ALASKAN WAY VIADUCT

EVALUATION OF GRAY'S RETROFIT PROPOSAL

Prepared for the
Washington State Department of Transportation

By
T.Y. Lin International

Figure 23a

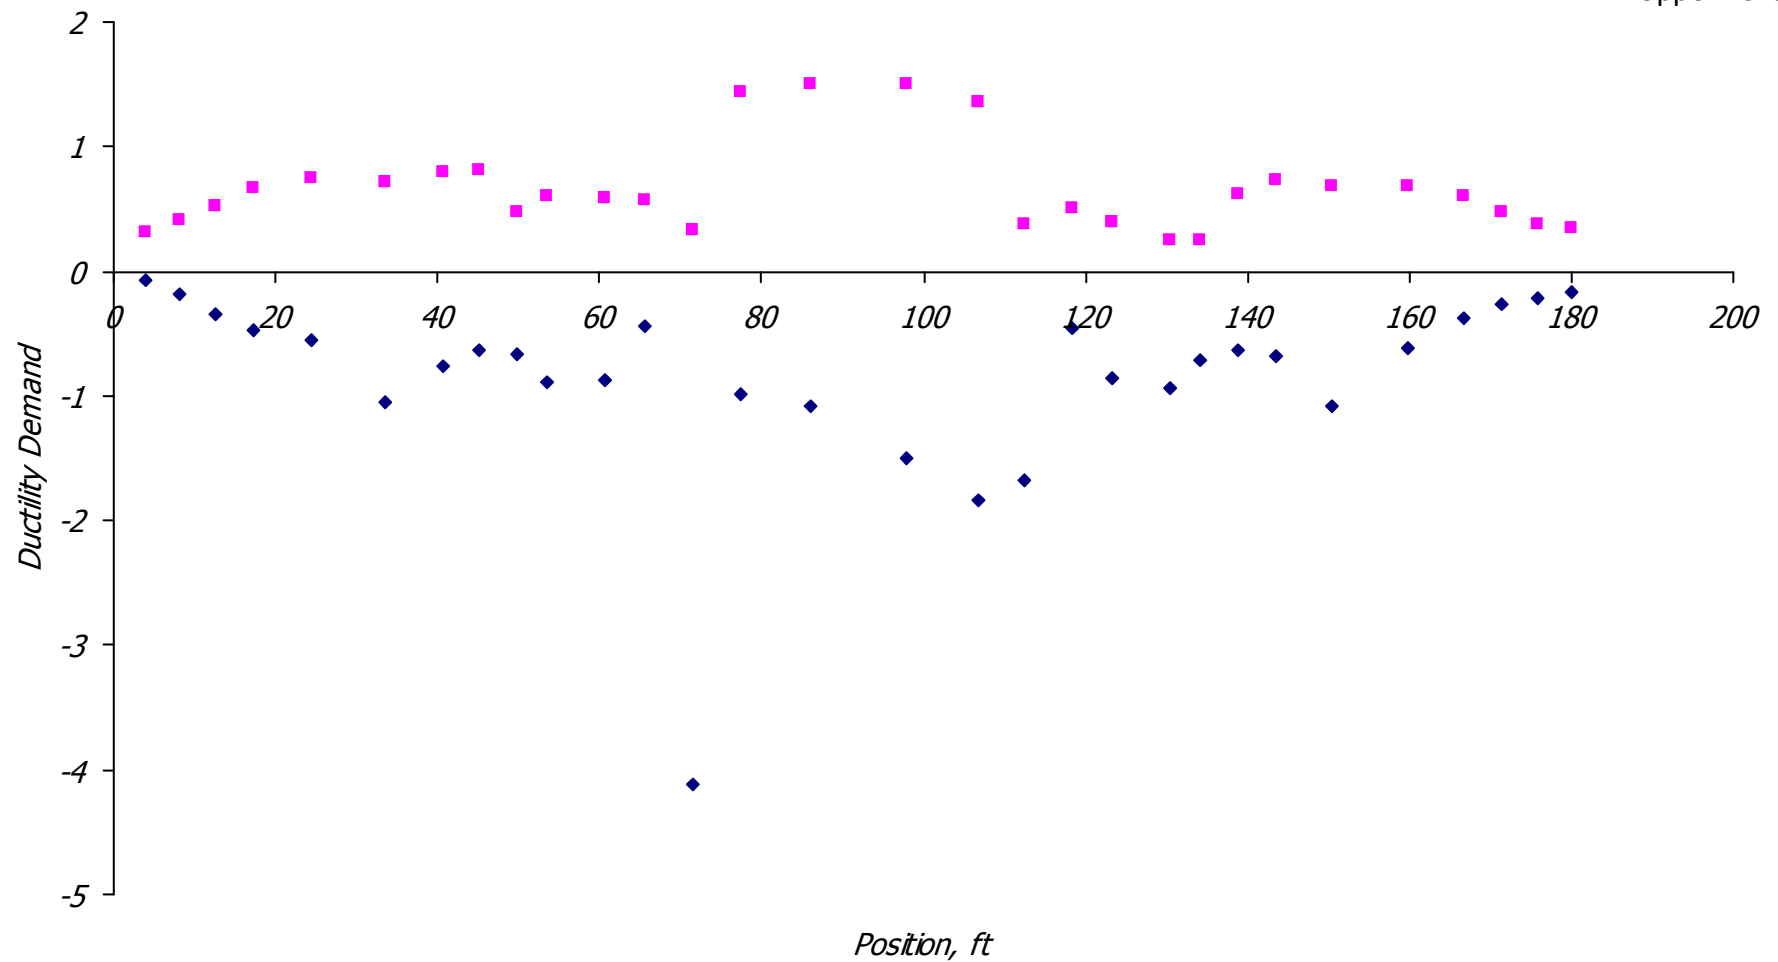
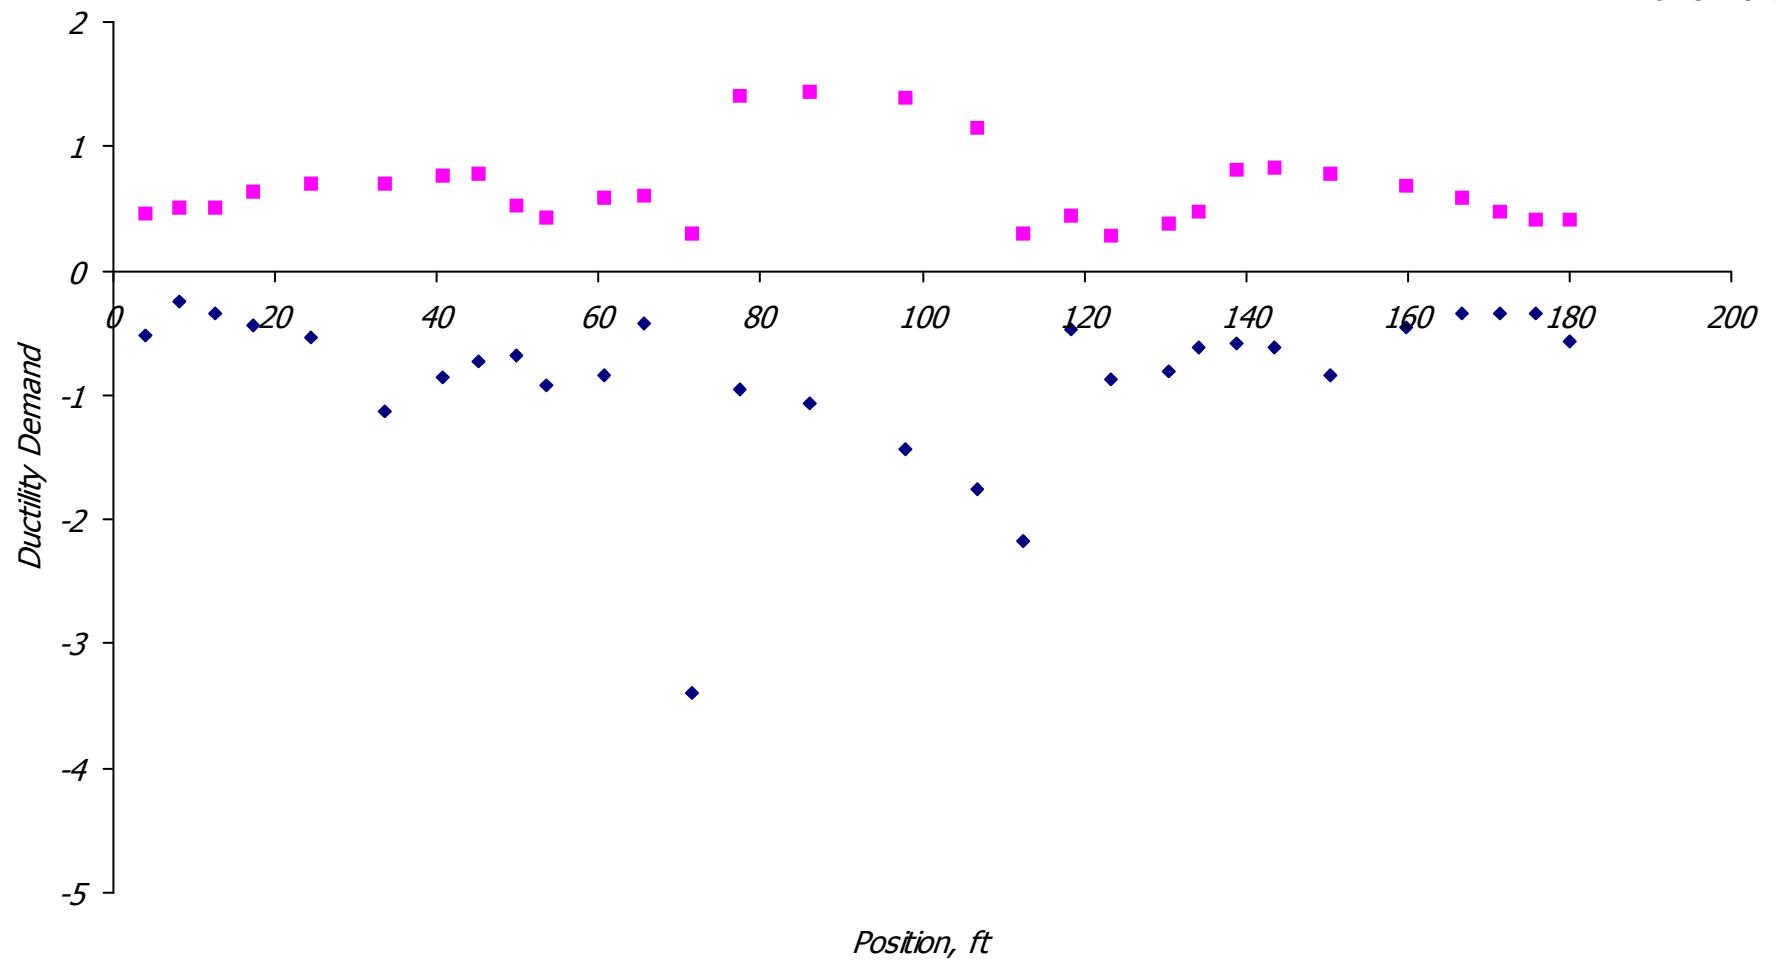
For the rare earthquake, the curvature ductility demands on the edge girders are summarized in Figure 23. There are separate plots for the upper and lower level girders; positive (\cup) and negative (\cap) demands are plotted together. Although yielding is indicated, the curvature ductility demands are modest and comfortably less than the capacity of the girders. The largest demand occurs in negative bending, at some distance from a column face, near a cut-off of top reinforcement. It may be that the demands on the girders are small because the longitudinal auxiliary frames prevent displacement of the upper level of the structure relative to the lower level.

Figure D.8 Column curvature versus axial force, retrofitted structure, rare earthquake, middle bents

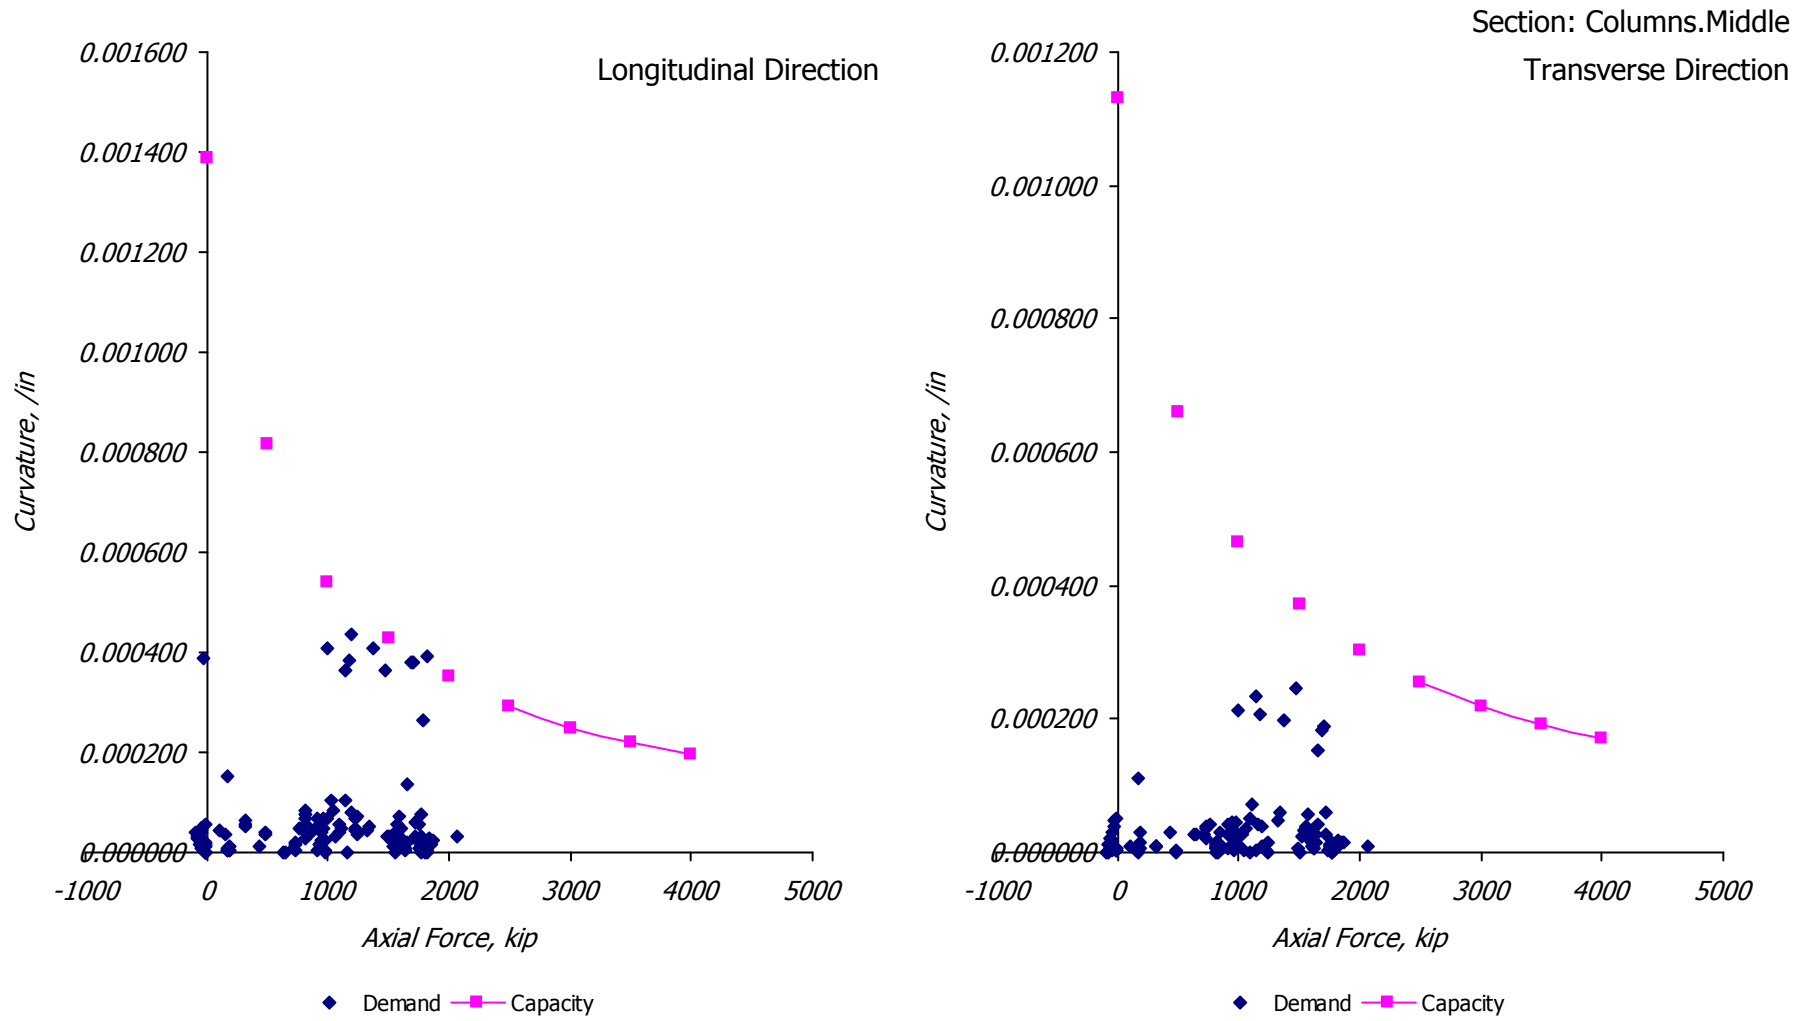
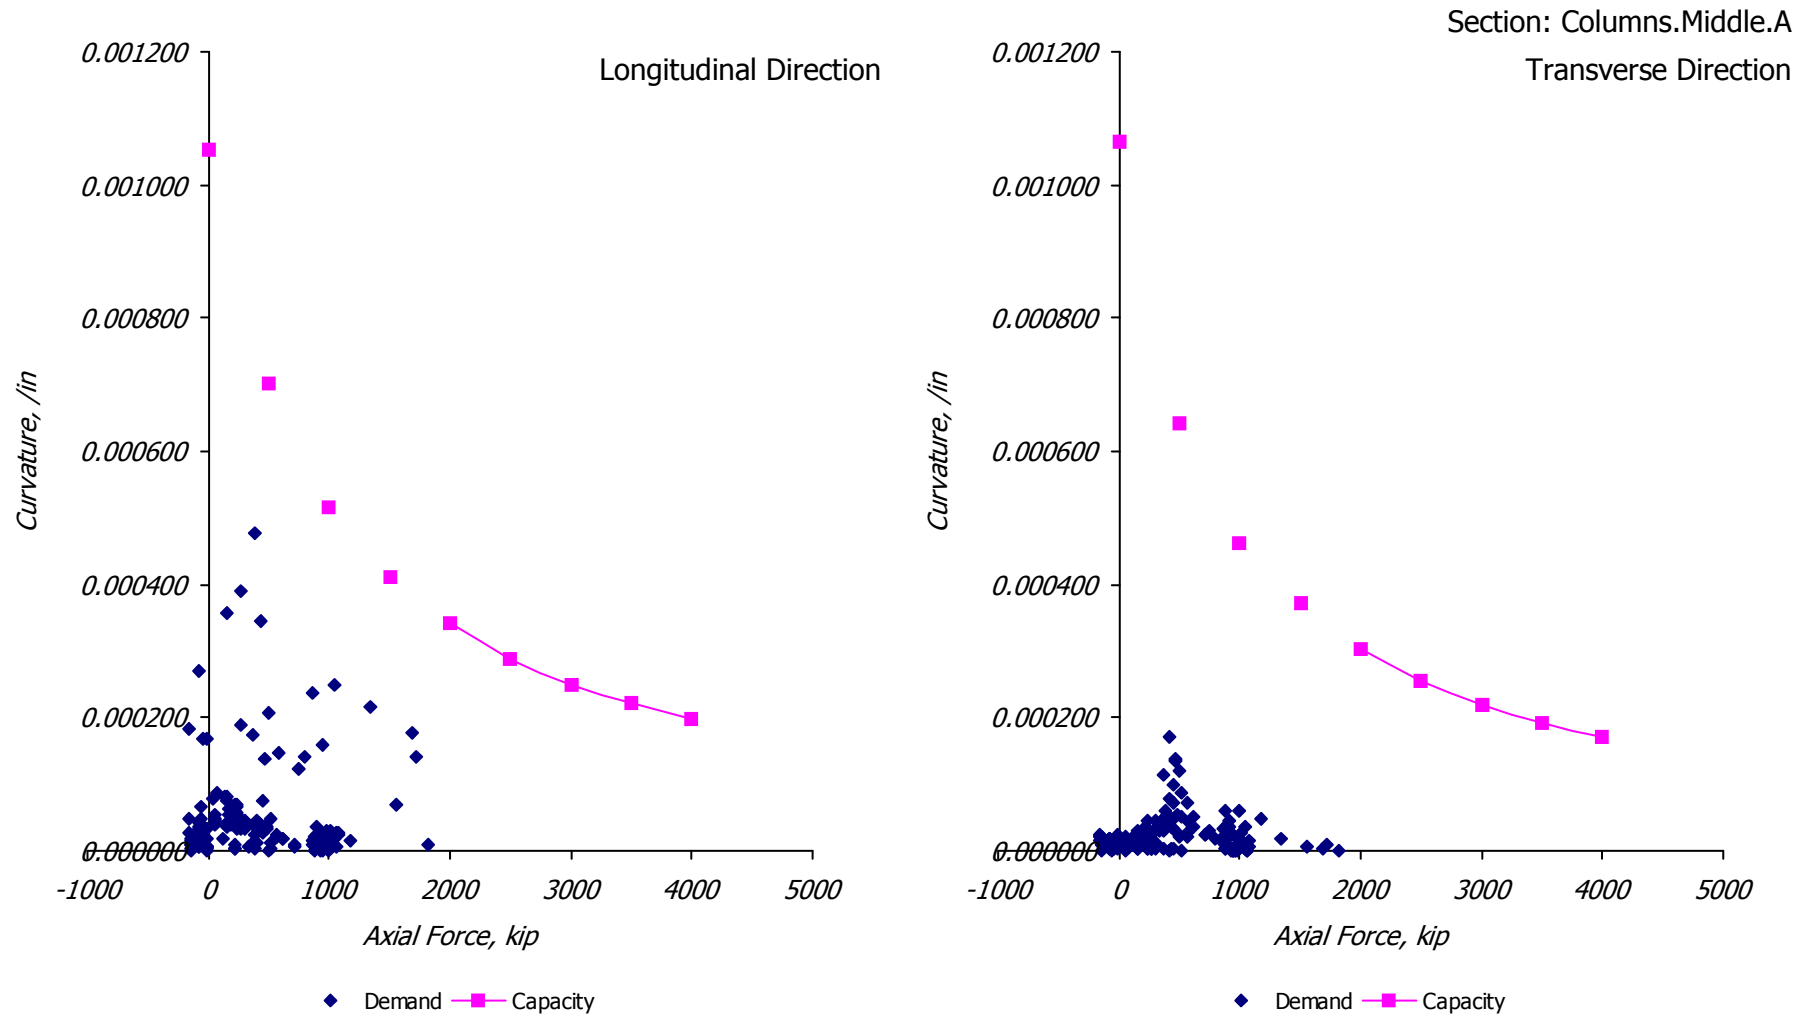
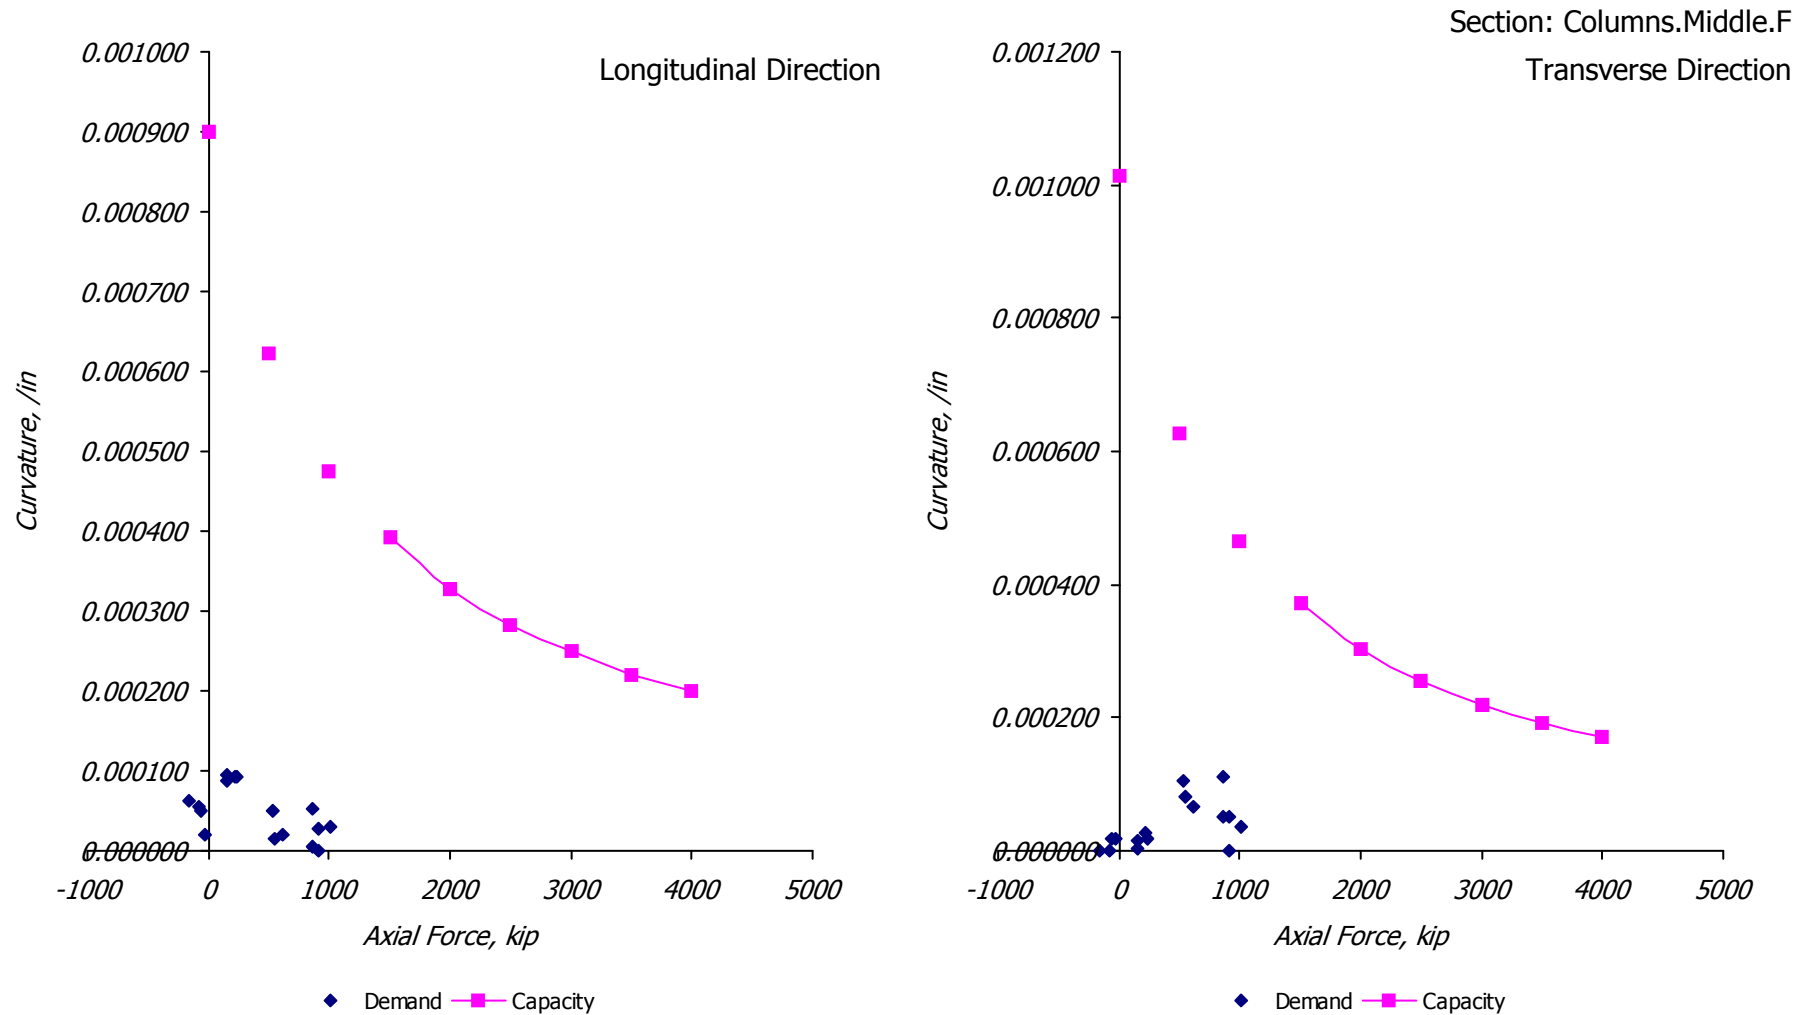
Figure D.8 shows that the flexural demands on the middle columns slightly exceed the capacity in the longitudinal direction, for the section designated “Columns.Middle” (the typical section). (In design, one would insist of a significant margin between the calculated demands and the capacity, to compensate for uncertainty in either analysis or capacity evaluation.) Figures D.7 and D.8 compare the demands to the capacity of the *existing* structure. Miyamoto’s proposal does include improvement of the flexural and shear capacity of the columns by wrapping them with ductile fiber wraps. The results presented herein indicate that some such retrofit is required. We have not evaluated the effectiveness of retrofit with fiber wrap, however.
